L625-
A.06.16

To: Official After Sales Network
Subject: Soft top latch update
Pages: 21

Soft top latch update

Huracan Spyder.

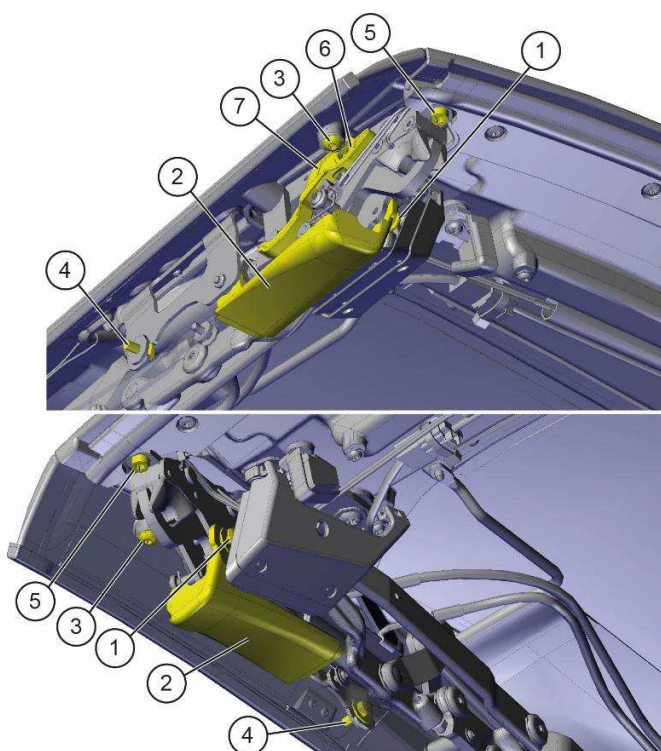
As a result of continuous product monitoring, Automobili Lamborghini Spa has found that on some vehicles the soft top latch might not operate preventing the top from closing or opening.

1. front latch cover locking screw;
2. latch cover;
3. front seal mounting screw;
4. rear seal mounting screw;
5. front latch mounting screw (replace during re-assembly) and 2 washers;
6. lever mounting screw (replace during re-assembly).

- upgrade of the soft top latch and software for vehicles whose **VIN is included between GLA01563 and GLA05203**
- soft top software update for those cars whose Vin is greater than **GLA05203**
